1. PROPOSED BALCONY PLAN

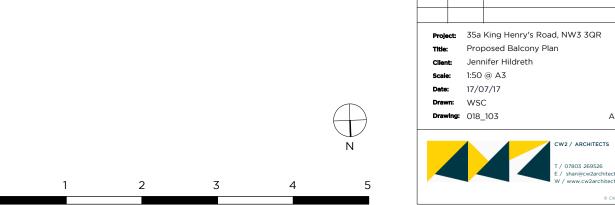
A 26/07/17 Balustrade height and material amendment to balcony
